MtIntosh

MX 112

FM/AM TUNER PREAMP

SERVICE INFORMATION

AM NOISE REDUCTION MODIFICATION

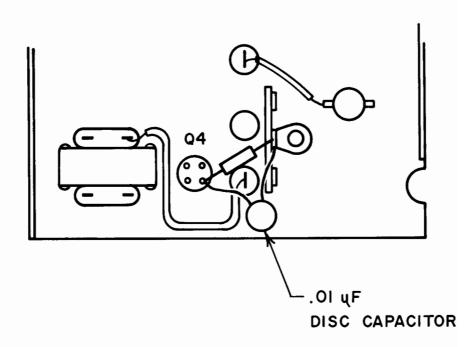
PURPOSE OF MODIFICATION: To improve AM signal to noise ratio.

WHEN MODIFICATION SHOULD BE MADE: When customer complains that AM is noisy on local stations or that sensitivity is poor.

- Step 1 Remove bottom cover, Multiplex-AM top cover, and RF front end bottom cover. Remove capacitors C204 and C208 on AM PC board. See service manual for exact location. Replace top cover.
- Step 2 Locate Q4, AM RF amplifier in RF front end chassis. Connect the .01 μ F disc capacitor between the source terminal of Q4 and the ground lug of the terminal strip as shown in the accompanying sketch. Replace bottom covers.
- Step 3 Check performance. If dial calibration is off at high end of the band, perform AM alignment steps 3 and 5 in service manual. The top cover of the RF front end is removed for access to the alignment trimmers.
